# SC430

## OUTLINE OF NEW FEATURES

The following changes are made for the new SC430.

273GX02

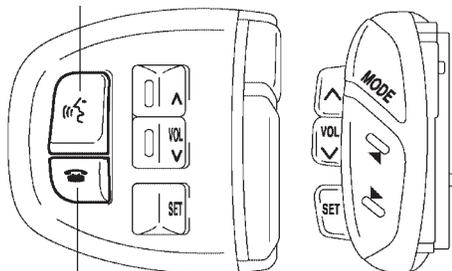
### 2. Multi Display

Models for the G.C.C. countries are equipped with the multi-display as standard equipment. The following points are changed.

Item	Outline	Destination	
		Europe	Others
System Diagram	A microphone for voice recognition function is added to the overhead console.	○	—
	Steering pad switch is added.	○	○
Screen Display	Along with the functions that are added or changed, the screen design is changed.	○	○
LEXUS Navigation System	A voice recognition function is added. Only English and German can be recognized in this function.	○	—
	<ul style="list-style-type: none"> <li>● In the navigation ECU, the process for calculating the information that is input from the GPS (Global Positioning System) satellites is revised in order to improve the accuracy of the present location.</li> <li>● The voice guidance volume can now be adjusted at the steering pad switch (Audio Volume).</li> <li>● Numerous additions and changes are made to the display. For details, <a href="#">see page 45</a>.</li> </ul>	○	○
Cellular Phone	A function that supports the Bluetooth* type cellular phone is adopted. For details, <a href="#">see page 46</a> .	○	○

Diagnosis Screen Display	Diagnosis items are added for the cellular phone. For details, <a href="#">see page 47</a> .	○	○

273SC01

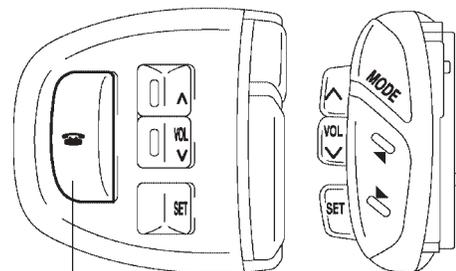
**4. Steering Pad Switch**

- Two switches are added on the steering pad switch in Europe models. One is for voice recognition function of the LEXUS navigation system. The other is for the Bluetooth type cellular phone.
- The switch to operate the Bluetooth type cellular phone is added on steering pad switch in other models.
